Town of Montgomery Police Station

ADDENDUM #2: April 17, 2025

General Summary:

Drawing: STAGING PLAN

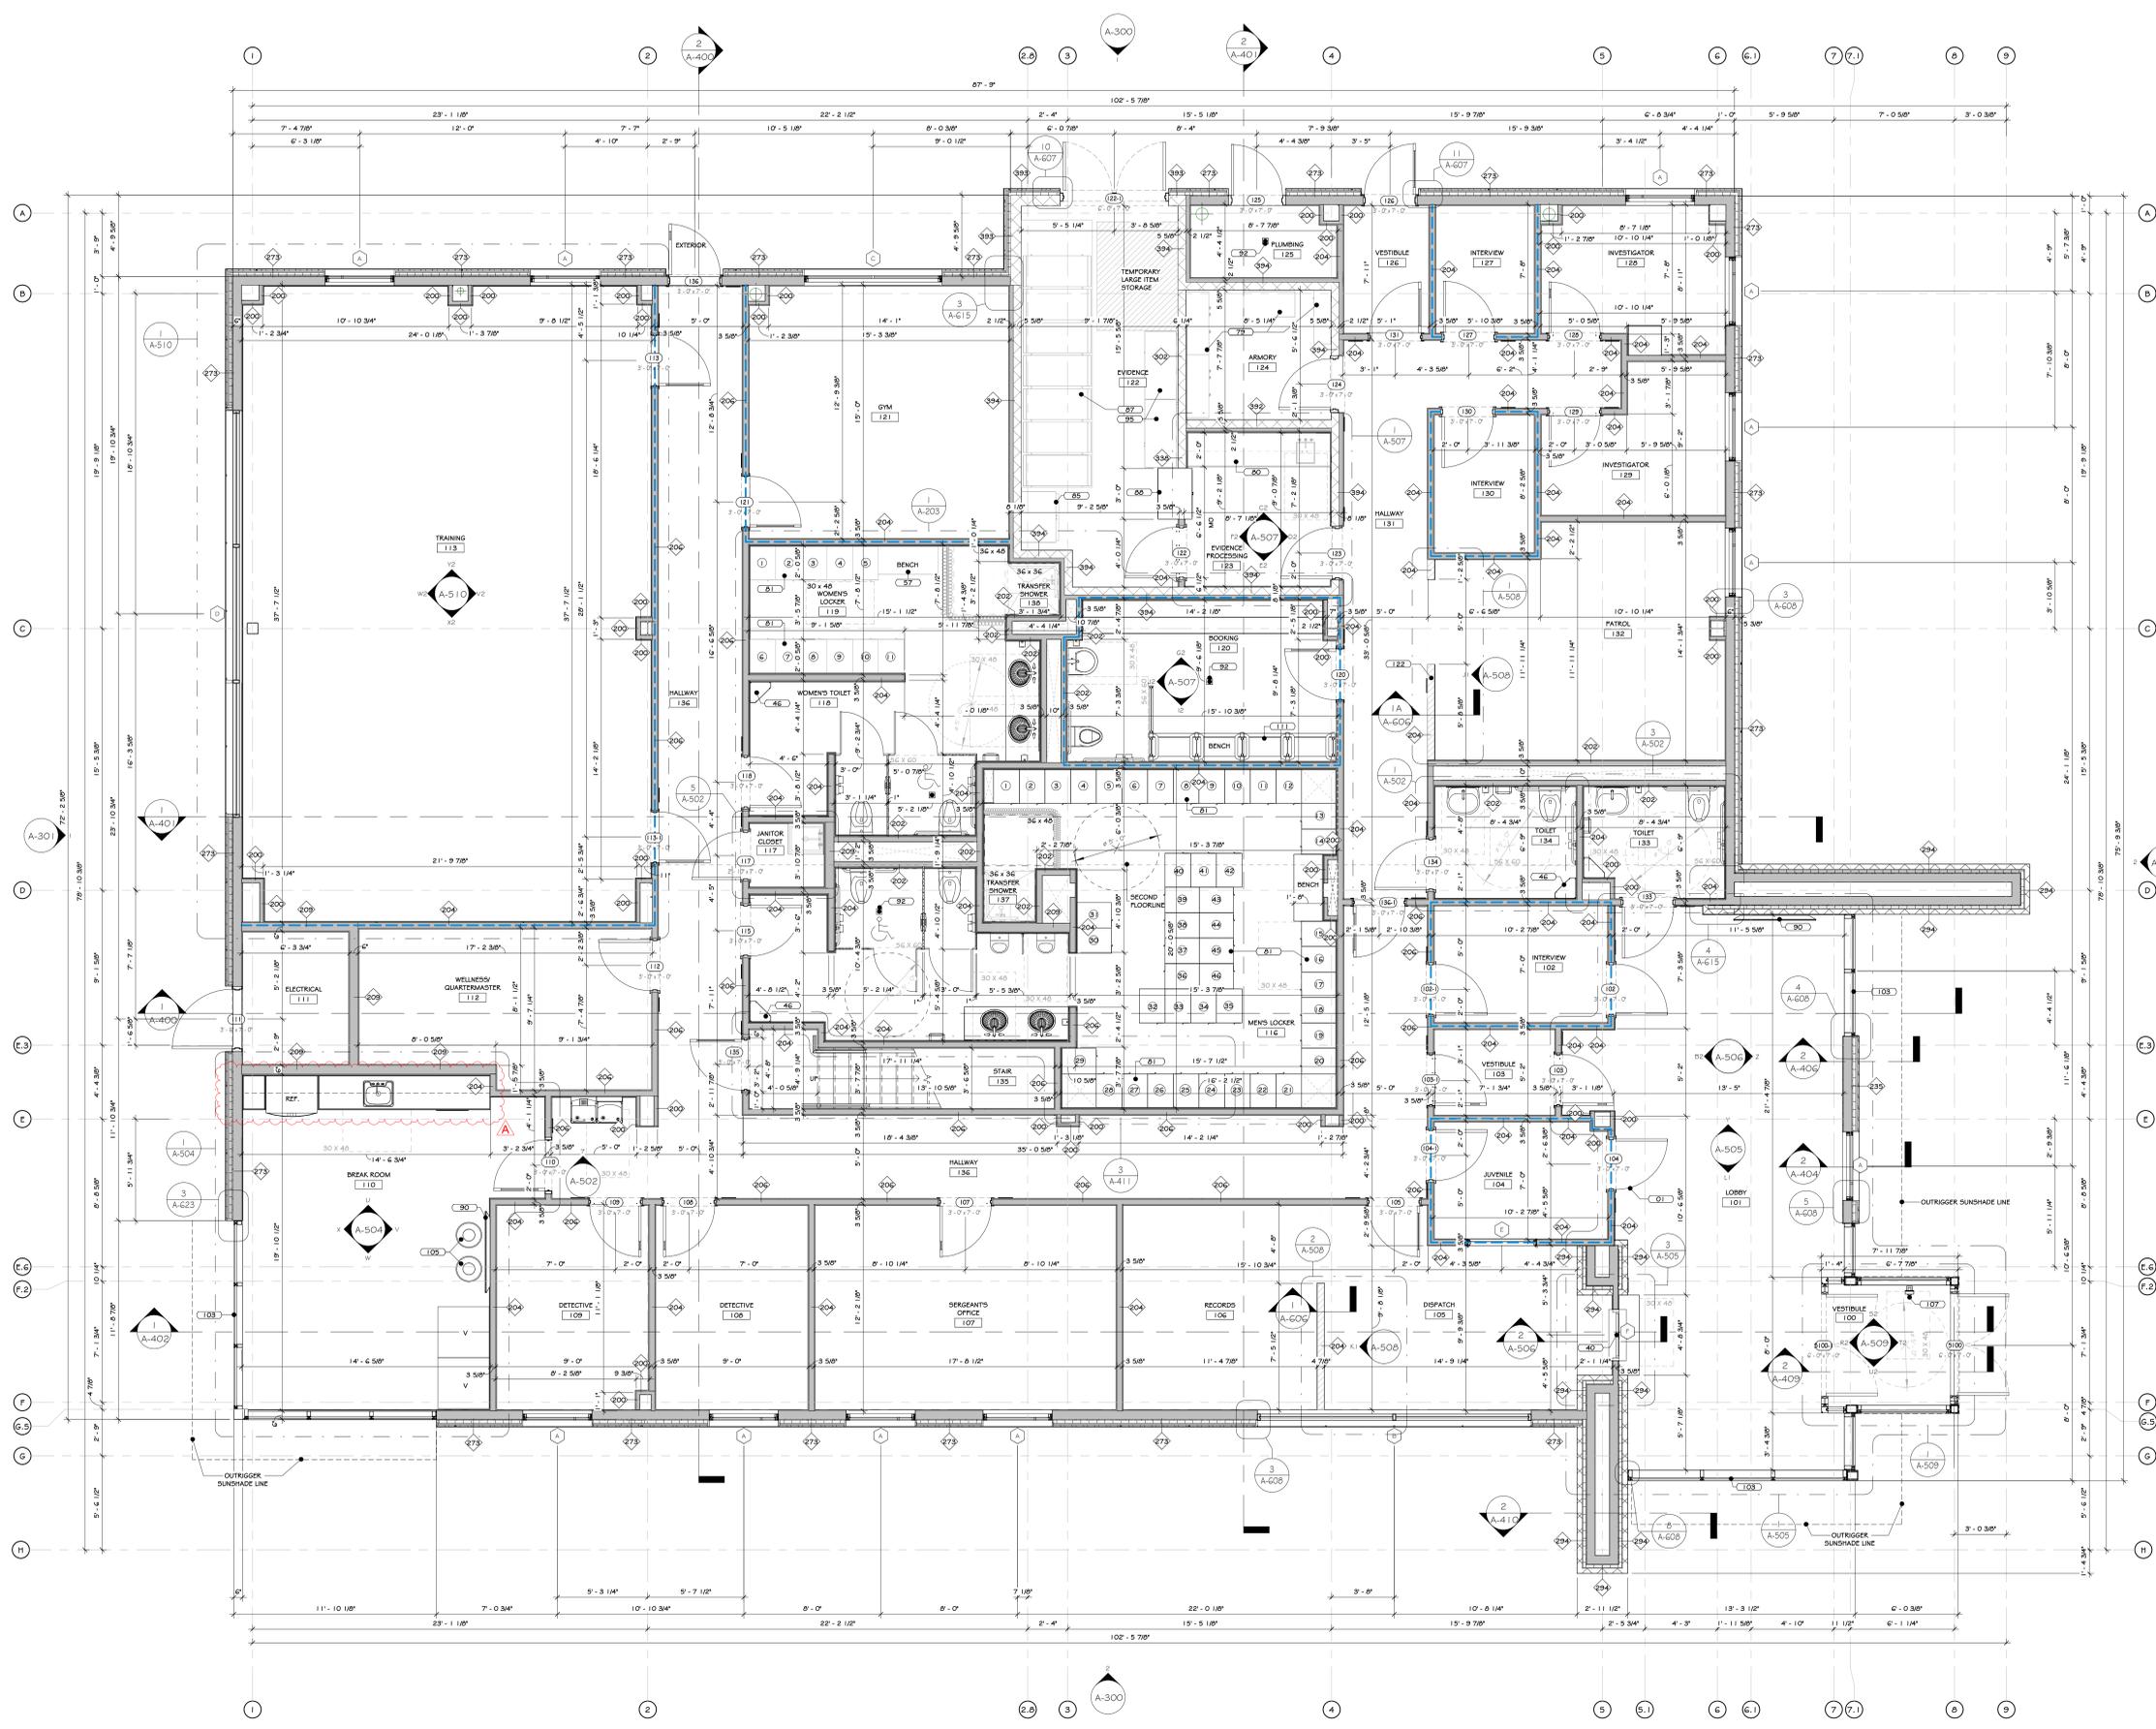
7. **As a notification**, architectural drawing A-010 – Staging Plan was added to show the construction staging area.
8. **As a notification**, architectural drawing A-100-ED – Existing Demolition Bench Plan has been updated.

Drawing: **FIRST FLOOR PLAN**

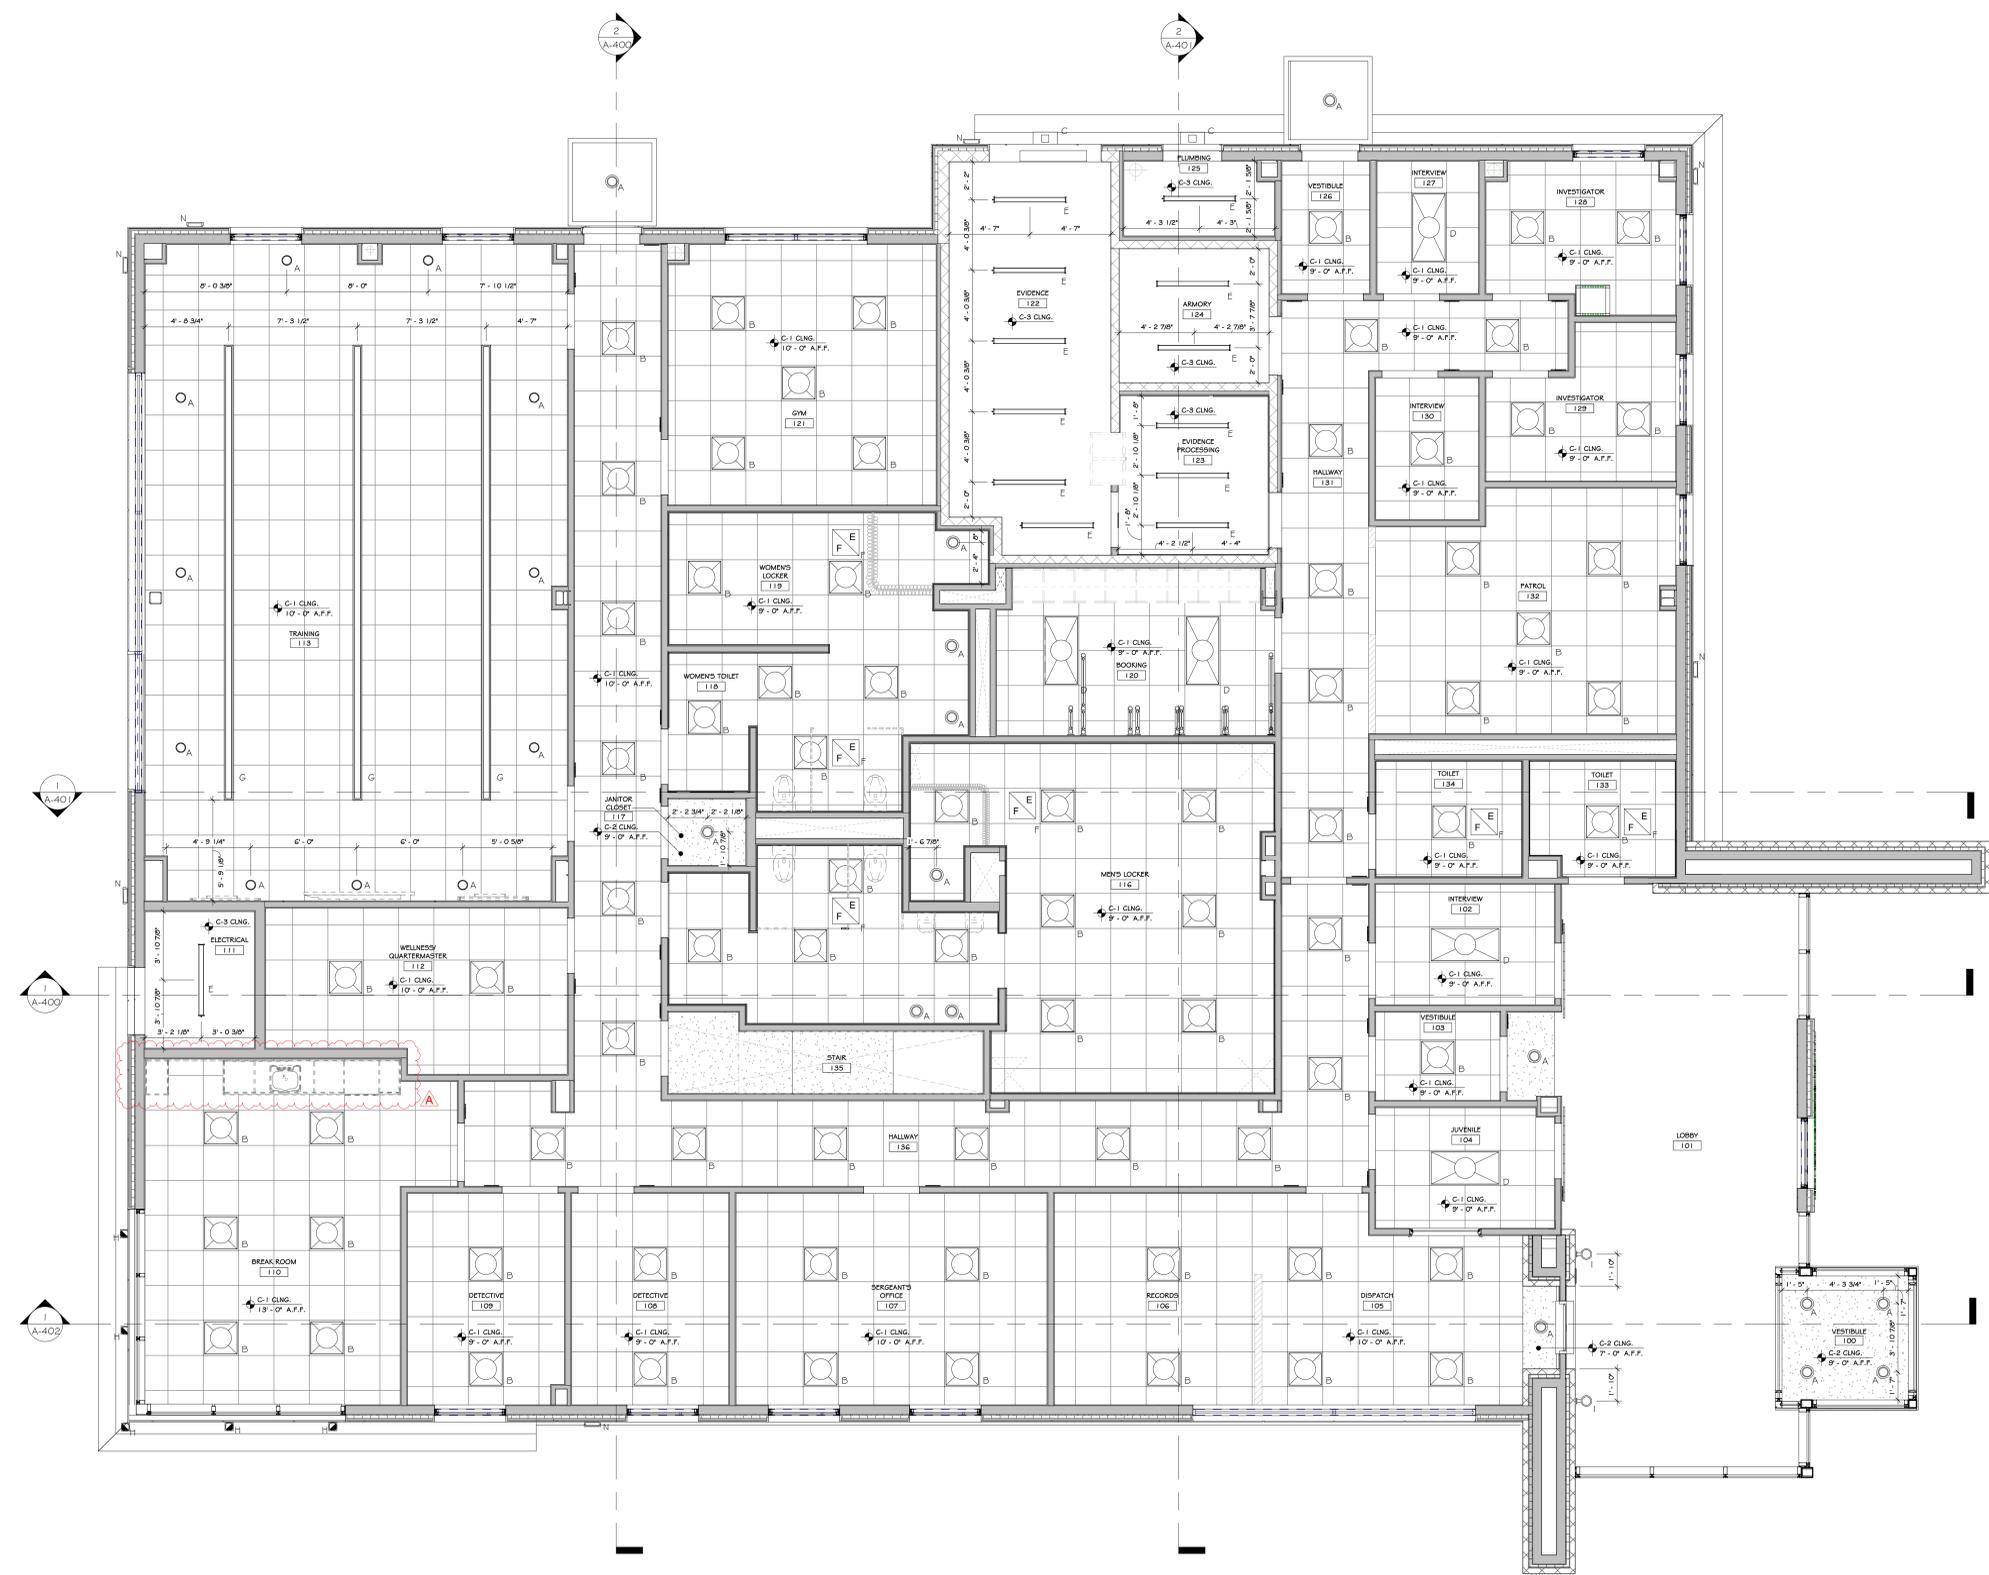
6. **As a notification**, A-005 - First Floor Life Safety Plan, A-201 - First Floor Plan, A-204 - First Floor RCP, A-504 - Break Room Interior Elevation, A-700 - First Floor Finish Plan, A-703 - First Floor Paint Plan, A-900 - First Floor Furniture Plan, and A-902 - Interior Sign Schedule were updated to adjusted break room casework layout.

Drawing: FIRST FLOOR IT-AV PLAN

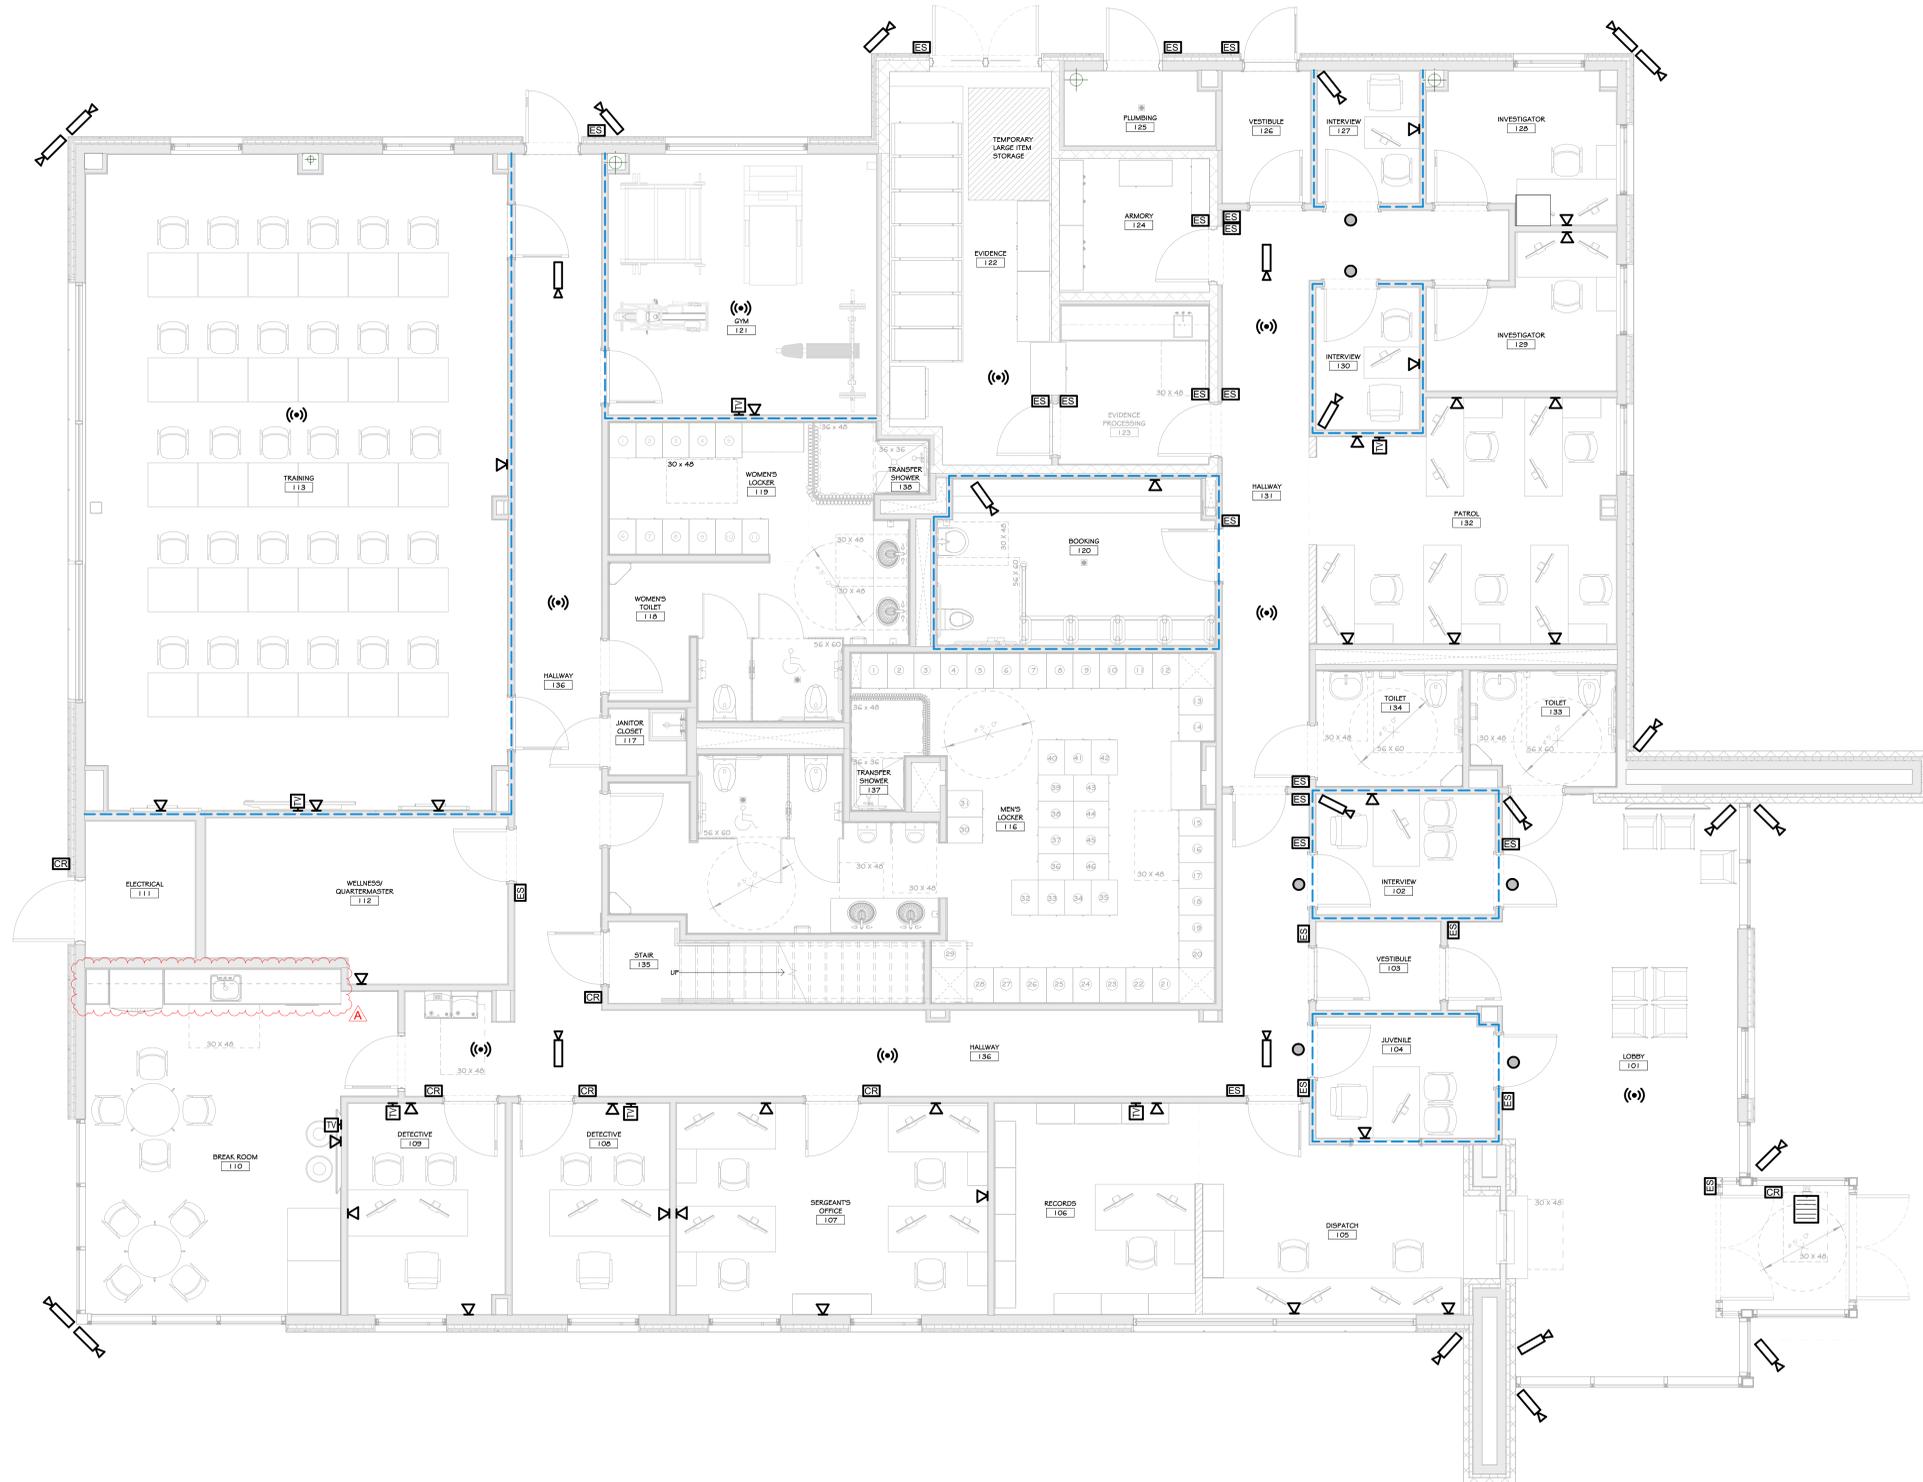
9. **As a notification**, architectural drawing A-702 – Finish Schedule was updated to show stainless steel casework in Room 120-Booking.
10. **As a notification**, architectural drawings A-903 - First Floor IT-AV Plan and A-904 - Second Floor IT-AV Plan have been updated to delineate the work to be included in the GC Bid and what the owner will be providing as related to IT/AV.

1. Is owner supplying & installing Furniture?
RESPONSE: The owner is responsible for supplying and installing all furniture.
2. What is to be included in the General Construction Bid for IT/AV?

RESPONSE: The construction notes on drawings A-903 - First Floor IT-AV Plan and A-904 - Second Floor IT-AV Plan have been revised to delineate the work to be included in the GC Bid and what the owner will be providing as it related to IT/AV.

- RESPONSE:** The general notes on drawings A-903 & A-904 have been updated to delineate the work to be included in the GC Bid and what the owner will be providing as it related to IT/AV.
